Access Compliance Report Public Rights-of-Way (Curb Ramps)

Main Street: N/A Cross Street: BEACH_BLVD Location: N

ADA ID: RPRK220203163737 Ramp Type: Type 7 - Directional 2 Initial Pass/Fail: Pass Overall Compliance: No Severity Score: 10

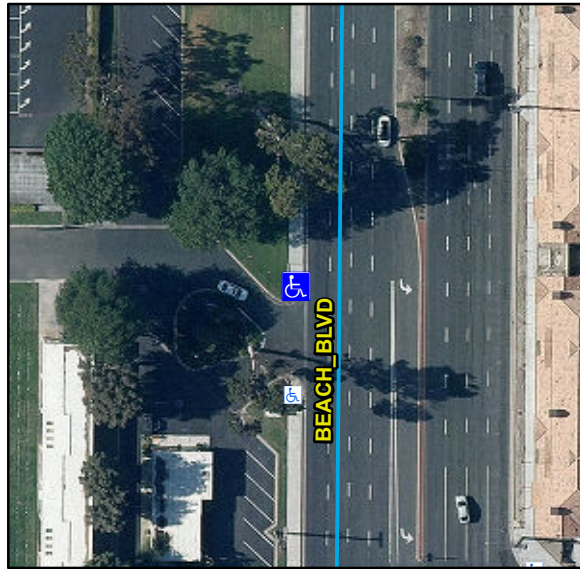
Remove & Replace Entire Ramp. Remove & Replace Gutter.

R304.2.1, R305.2, R302.7, R304.5.4, STD 1115
